## ADDENDUM NO. 1

PROJECT: Saline Area Schools – 2022 Bond Program – MS Rec Complex  
 DESCRIPTION: Addendum No.1  
 BID PACKAGE RELEASE NUMBER: BP #3

1. ADDENDUM No. 1, November 20<sup>th</sup>, 2024 as issued by Kingscott (Attached)
2. Bid Package T4 Draft Drawings, October 22<sup>nd</sup>, 2024 - Saline Middle School Rex Complex as issued by Barton Malow (For Reference Only)

# C1.1

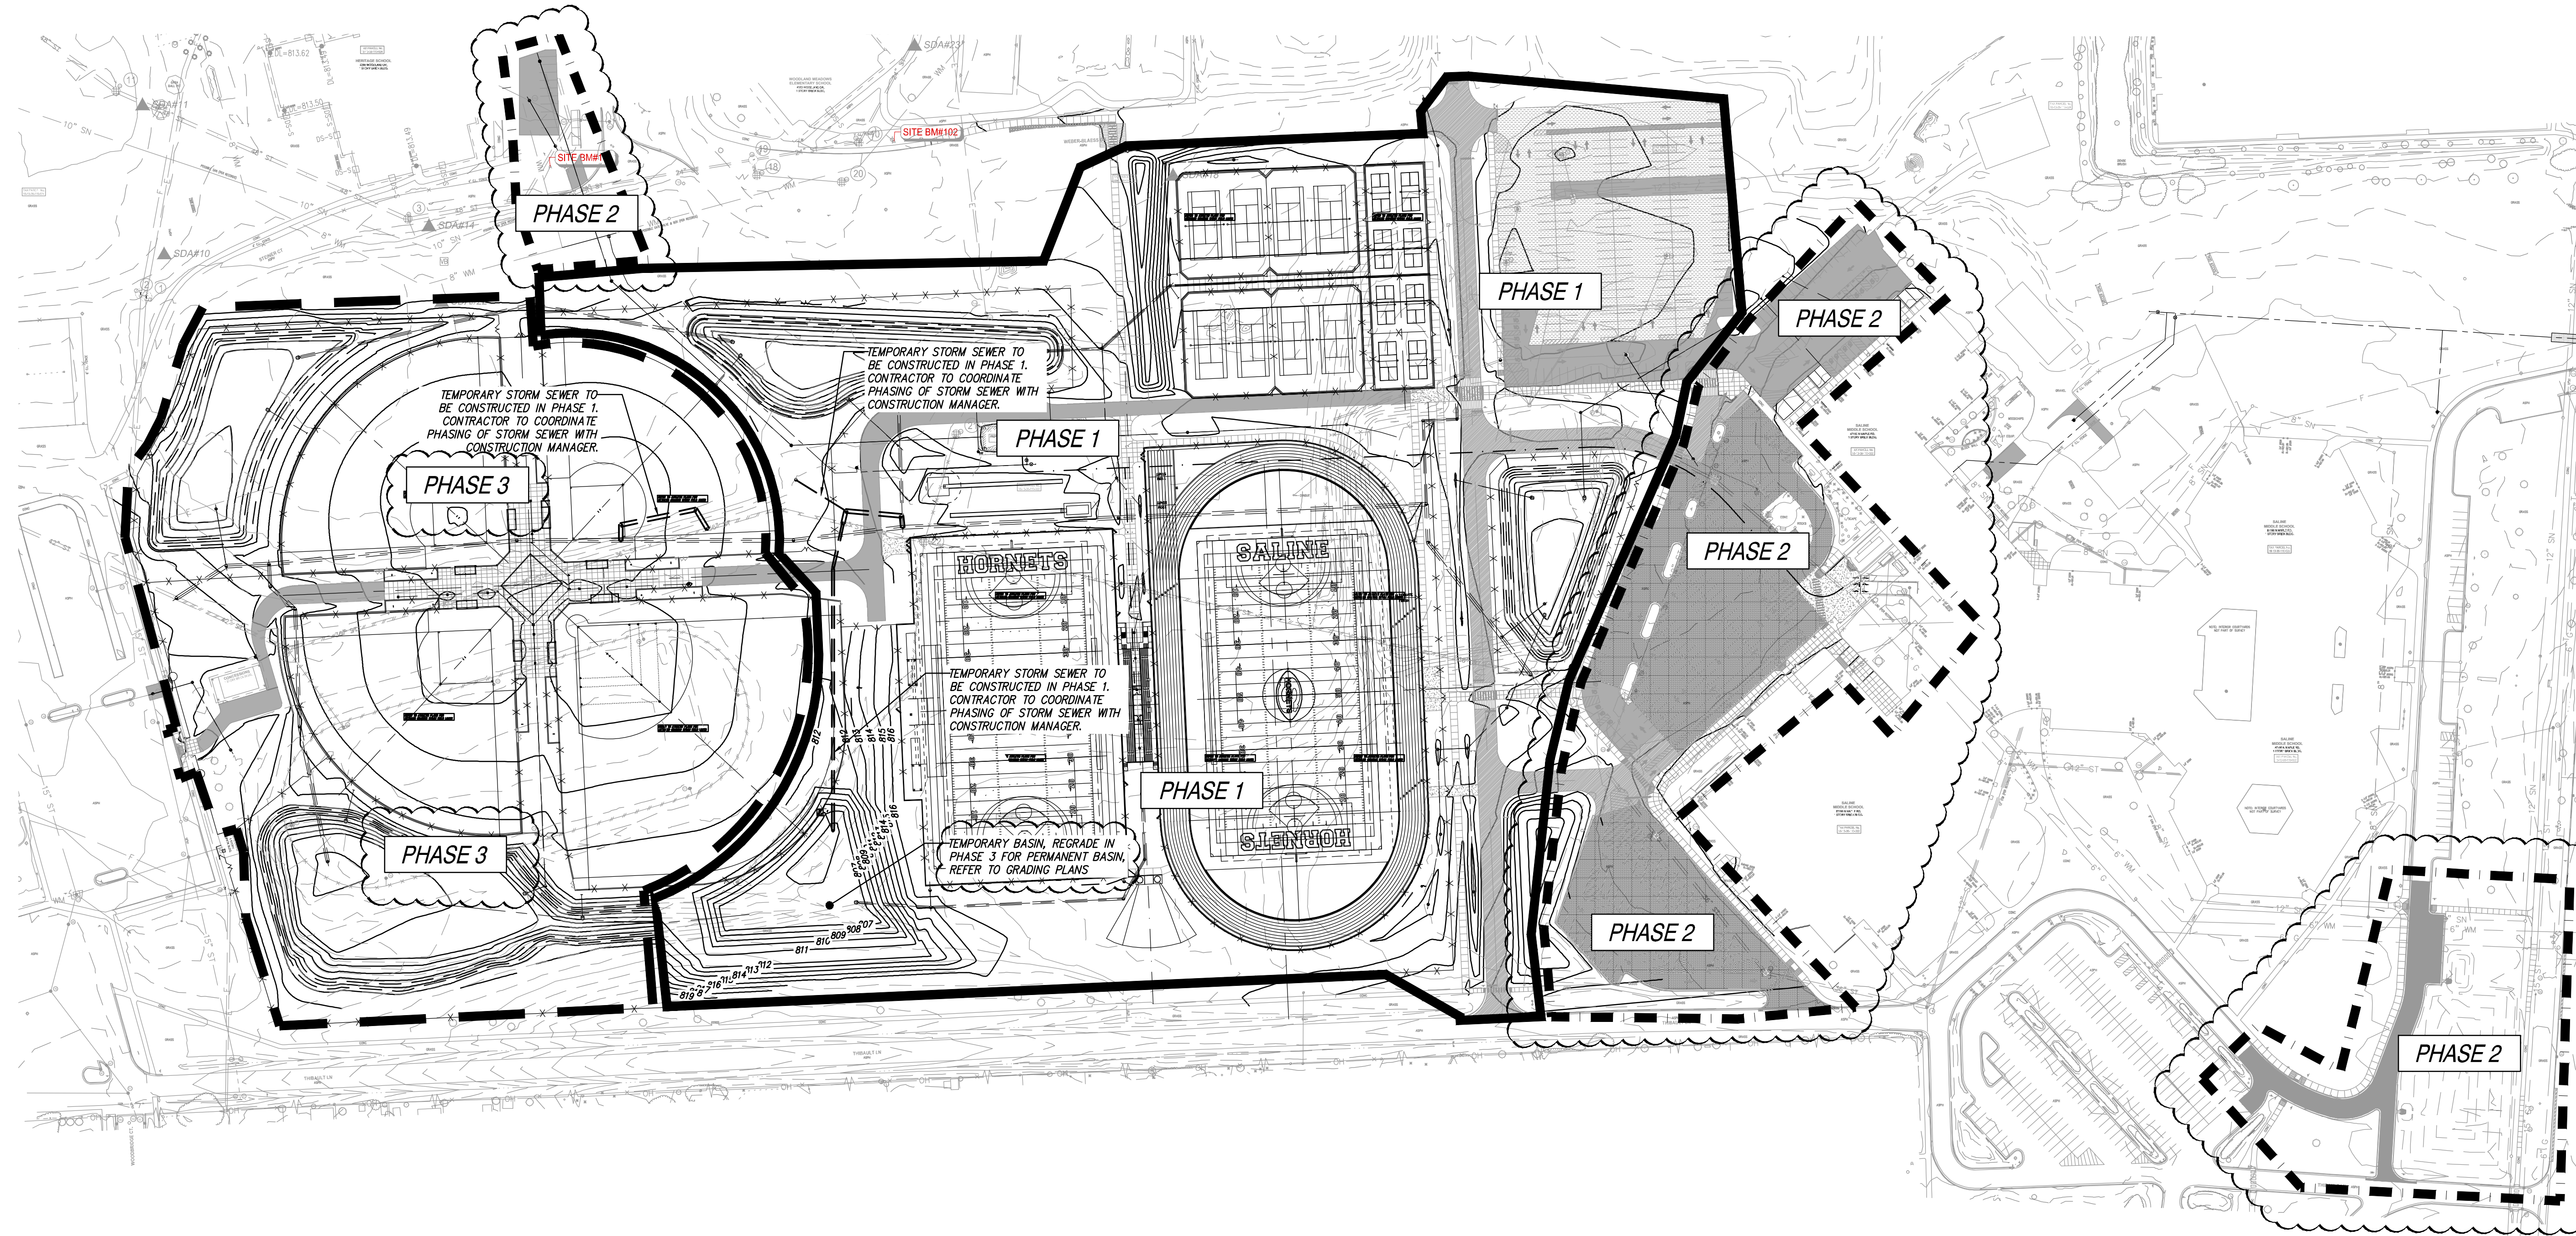
- Item No. 8: Revised phasing designations on sheet C1.1.**
- Item No. 9: Updated phasing callouts on sheet C1.2.**
- Item No. 10: Added "Overall Stormwater Narrative" on sheet C3.0**

SHEET NO.  
**C3.1**

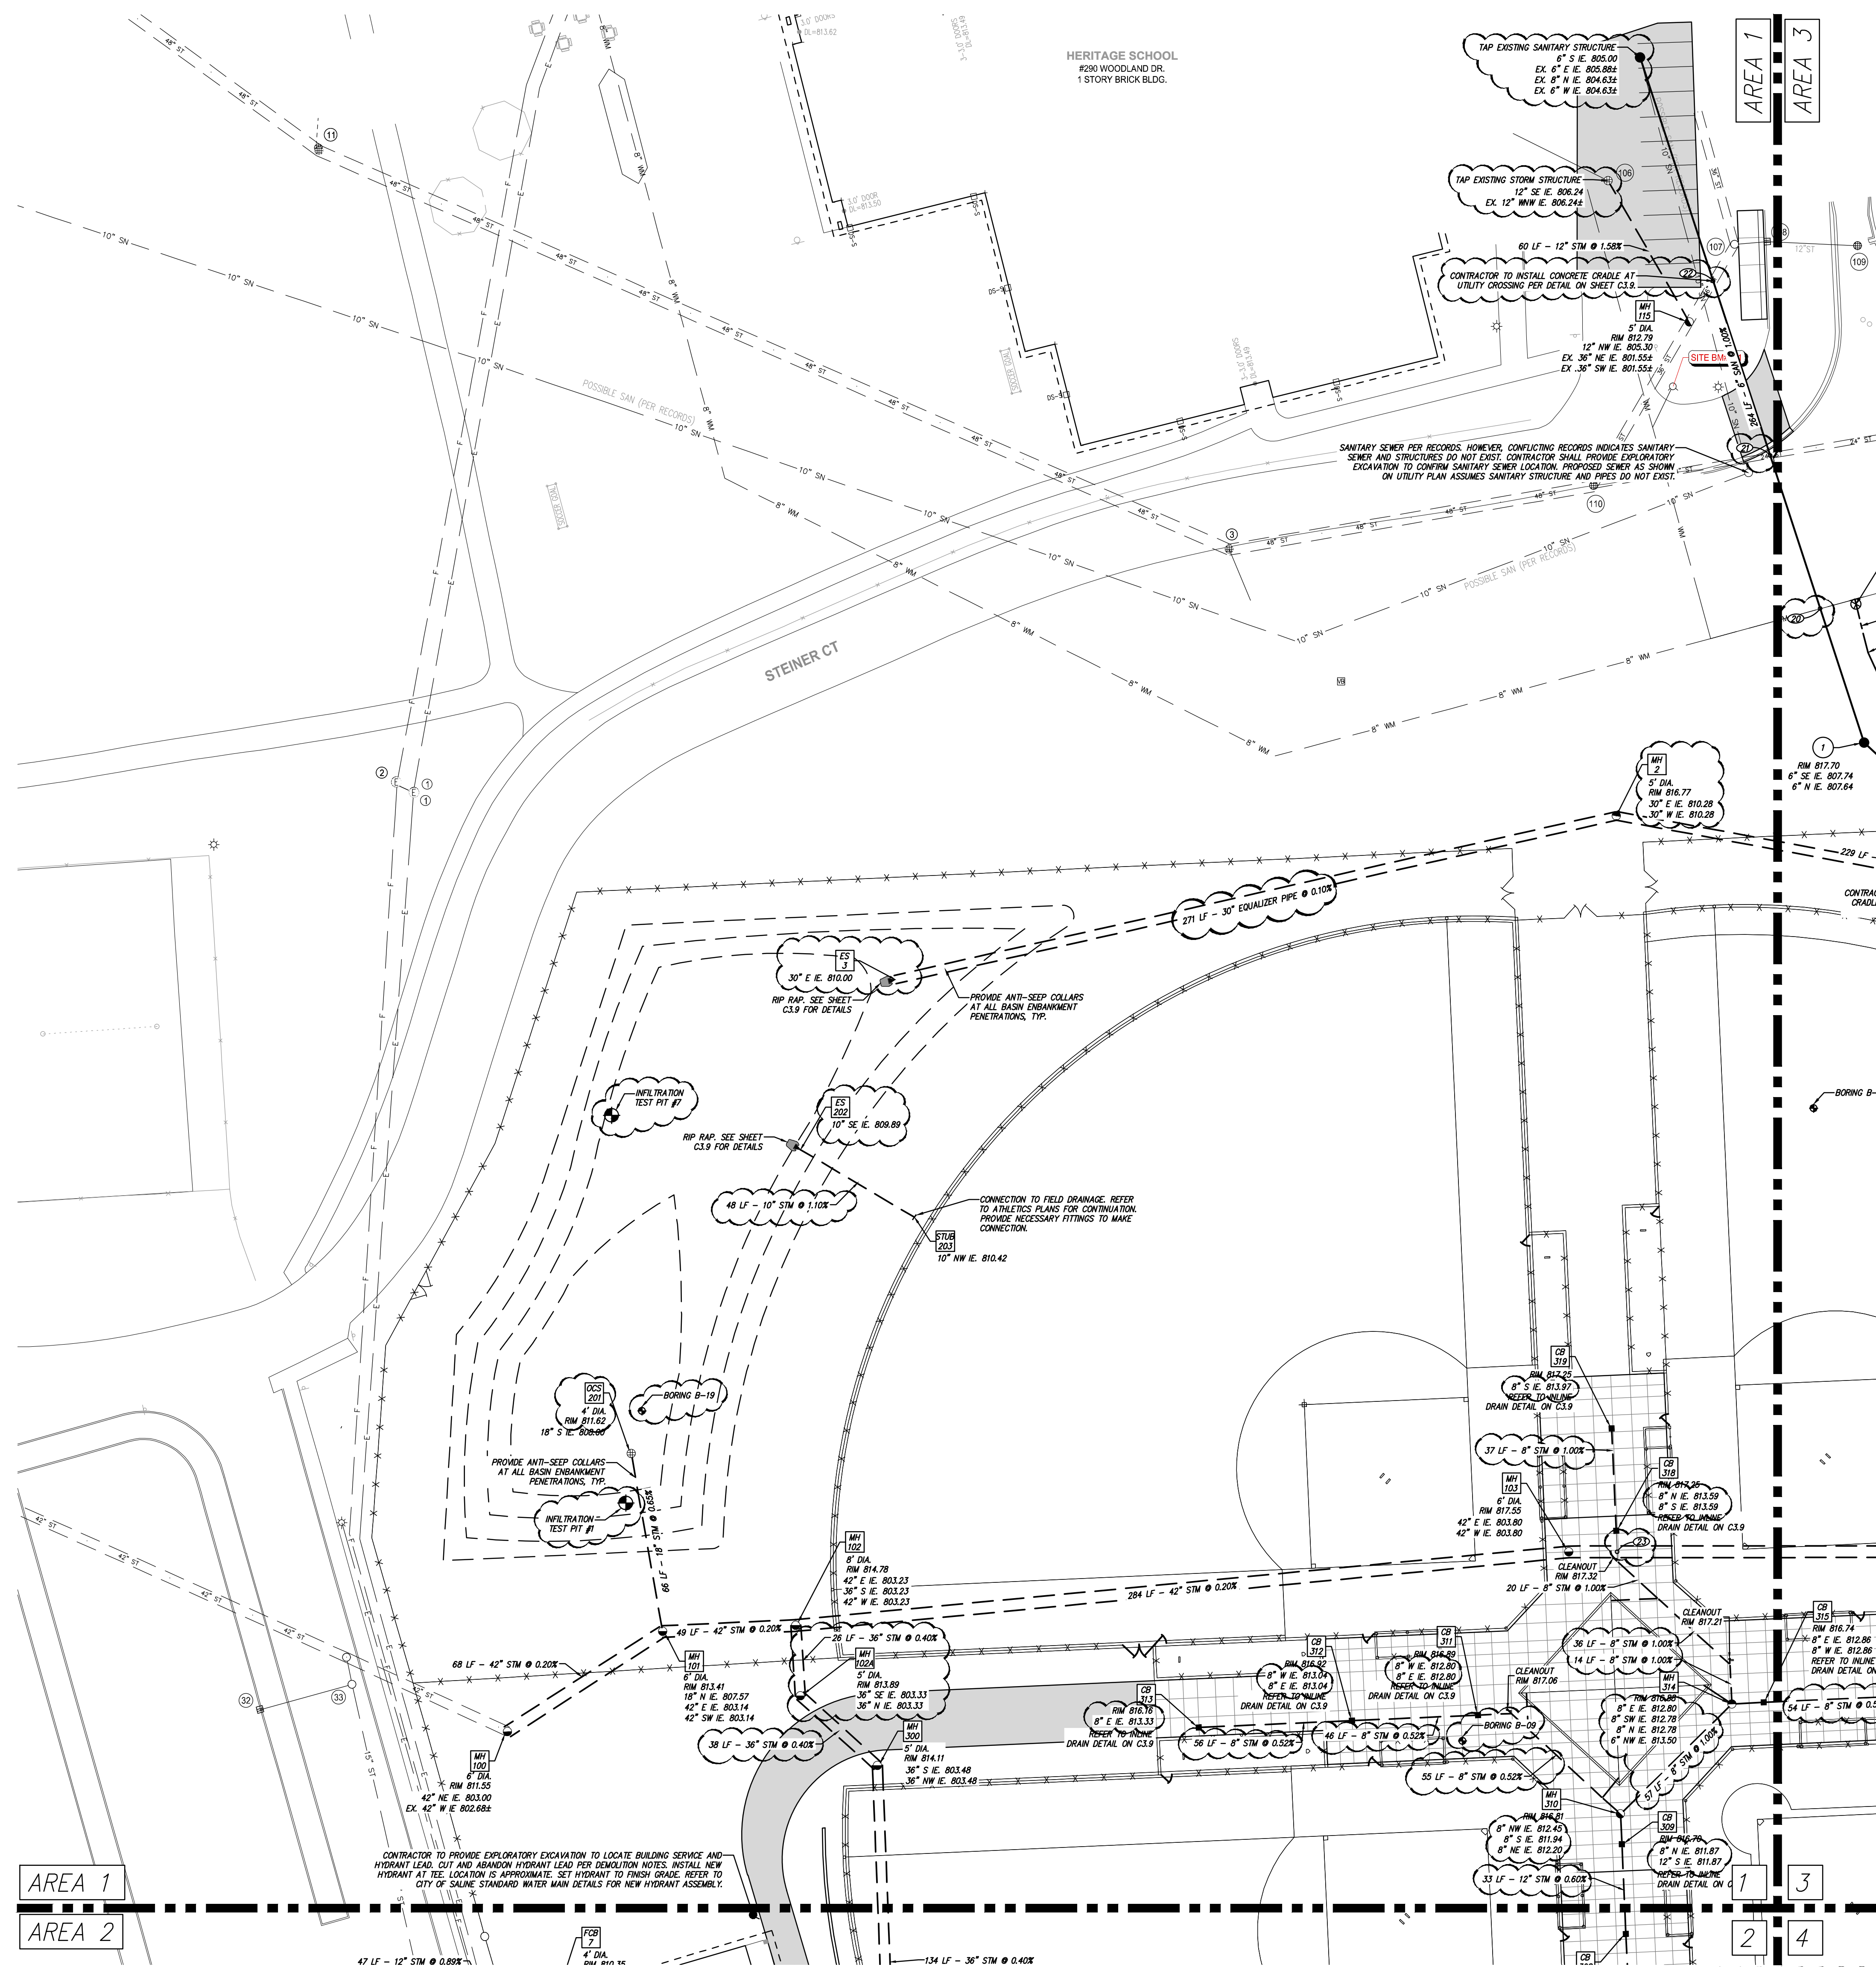
- Item No. 11: Revised inverts, pipe slopes, pipe and structure sizes, and pipe material on sheet C3.1.**
- Item No. 12: Added infiltration test pits on sheet C3.1.**

- Item No. 13: Added boring locations on sheet C3.1.**
- Item No. 14: Added utility crossing number(s) and crossing table on sheet C3.1.**
- Item No. 15: Revised concrete cradle note(s) on sheet C3.1.**

- Item No. 16: Revised rim elevation for standpipe on sheet C3.1.**
- Item No. 17: Revised inverts, pipe slopes, pipe sizes and material on sheet C3.2.**

SHEET NO.  
**C3.2**  
KINGSCOTT ASSOCIATES INC. KALAMAZOO, MICHIGAN

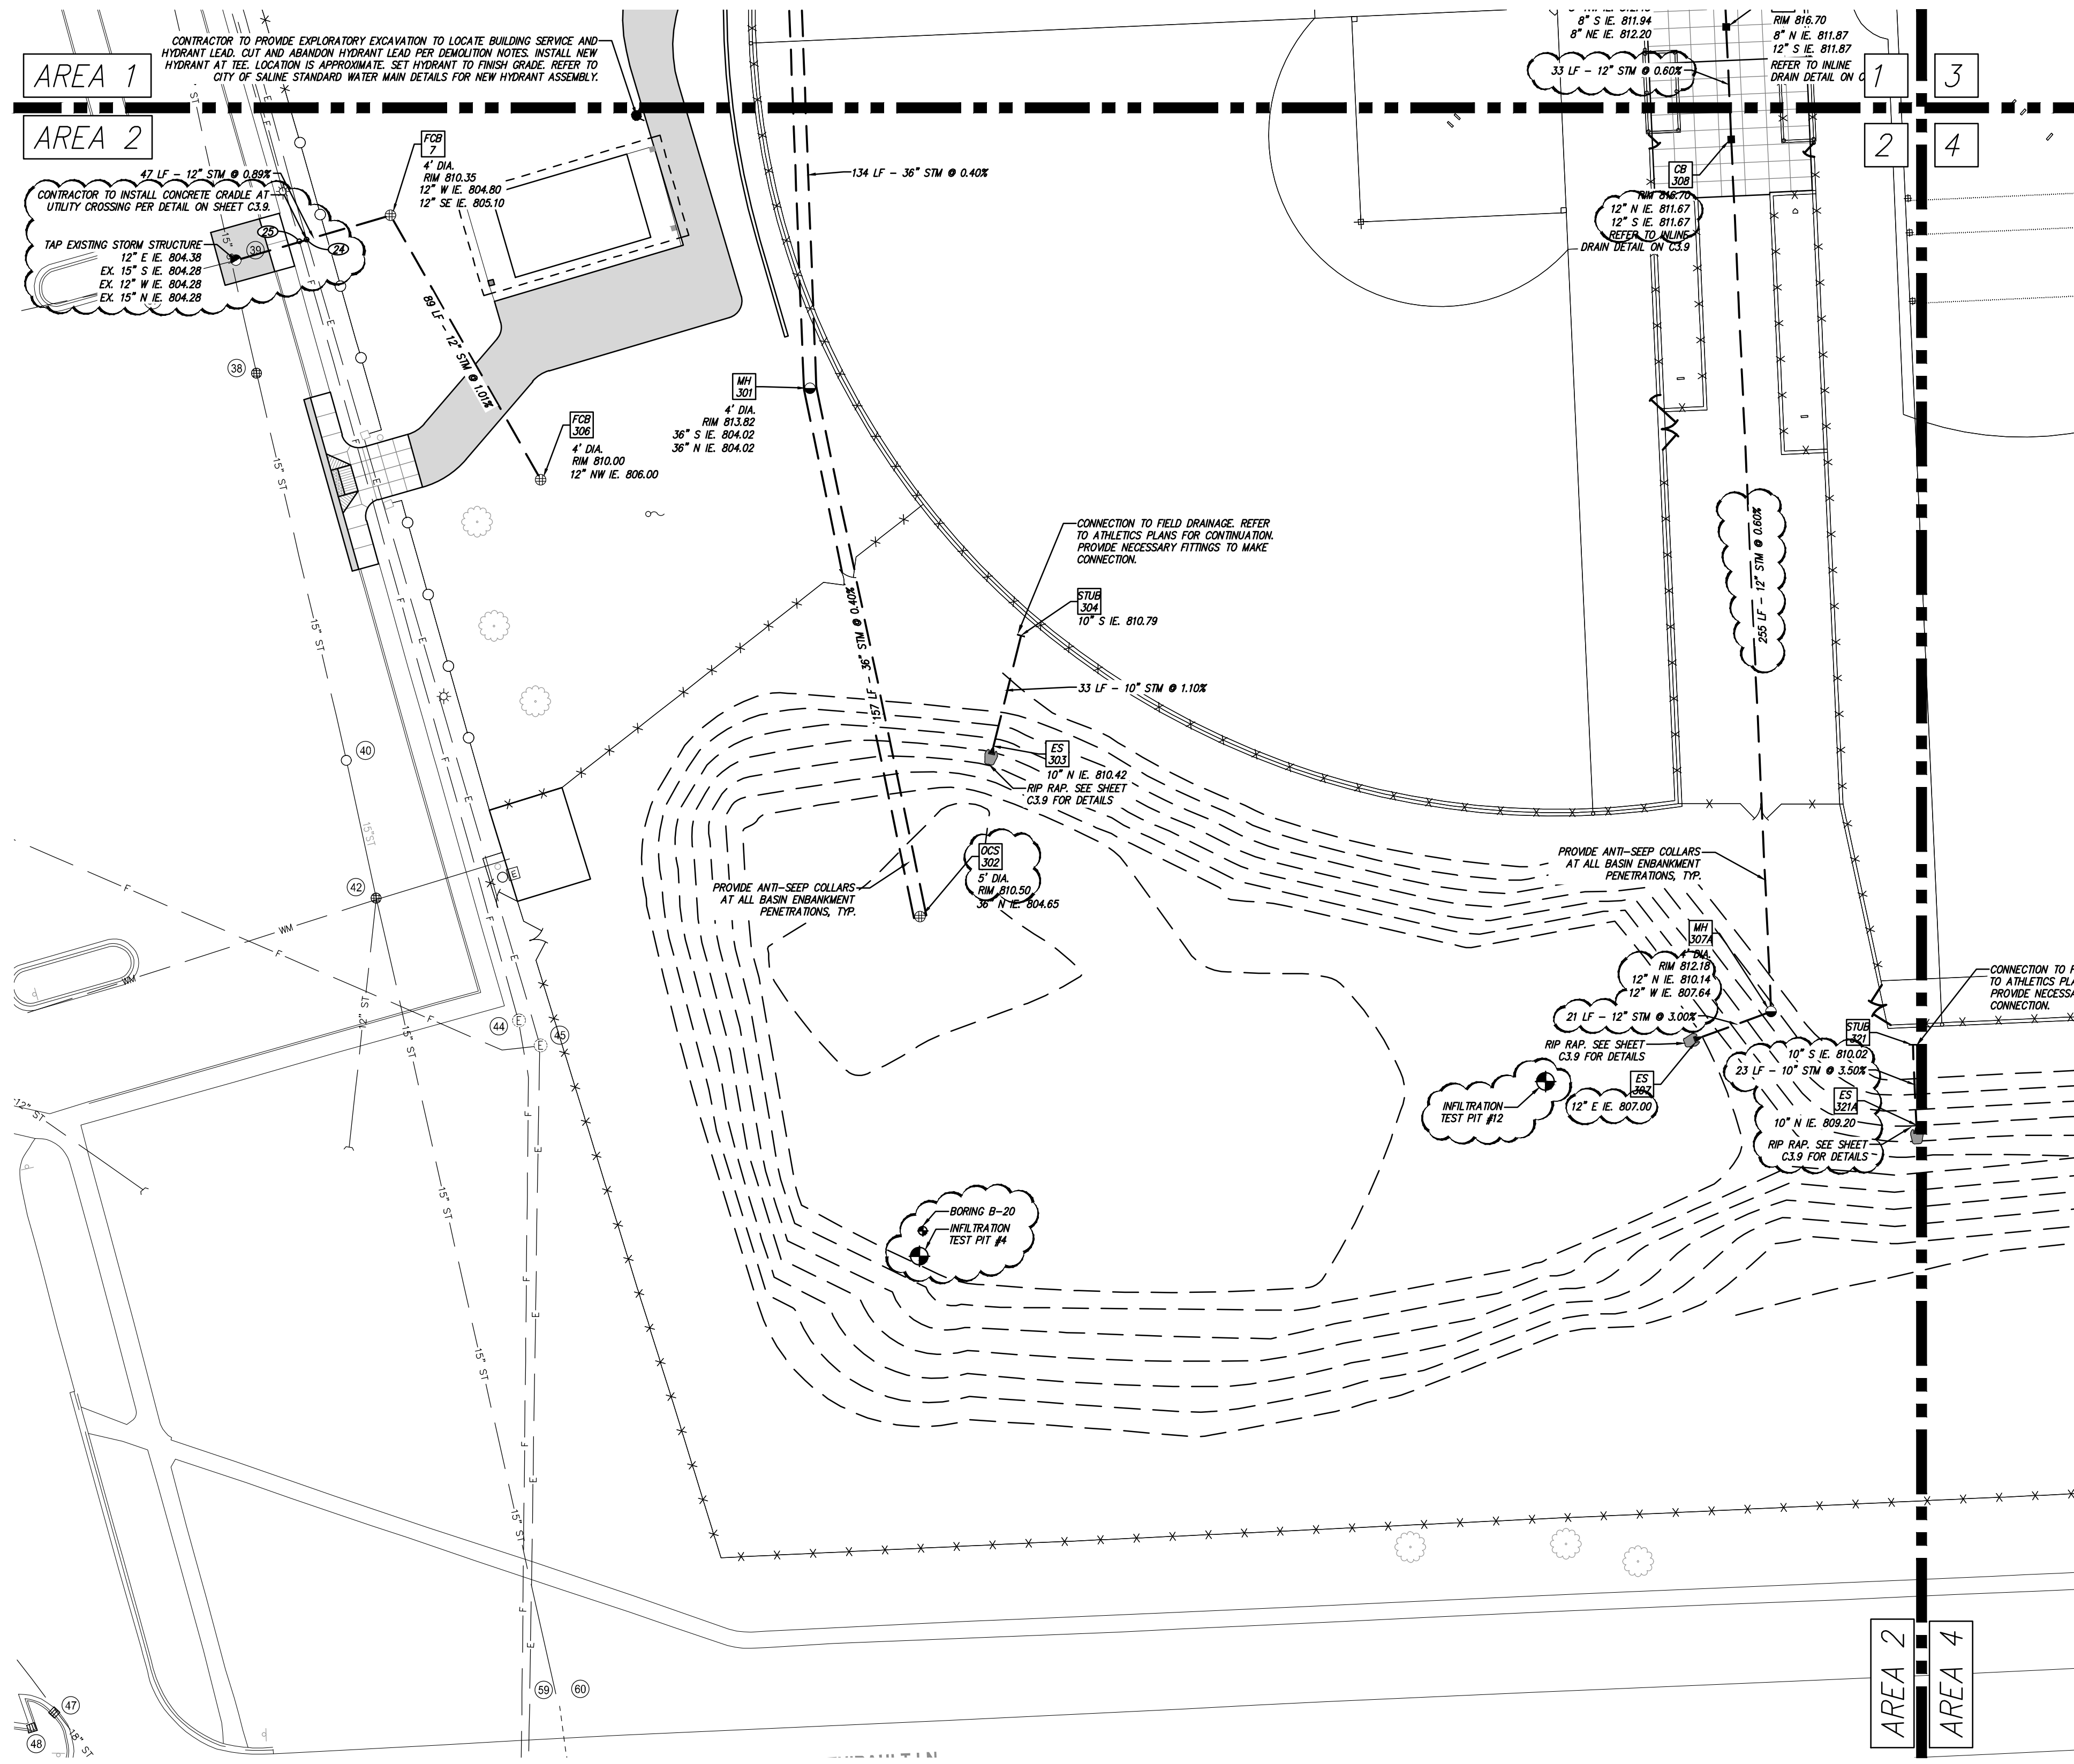
- Item No. 18: Added infiltration test pits on sheet C3.2.**
- Item No. 19: Added boring locations on sheet C3.2.**
- Item No. 20: Added utility crossing number(s) and crossing table(s) on sheet C3.2.**

- Item No. 21: Removed equalizer pipe and associated structures on sheet C3.2.**
- Item No. 22: Revised concrete cradle note(s) on sheet C3.2.**
- Item No. 23: Revised rim elevation for standpipe on sheet C3.2.**
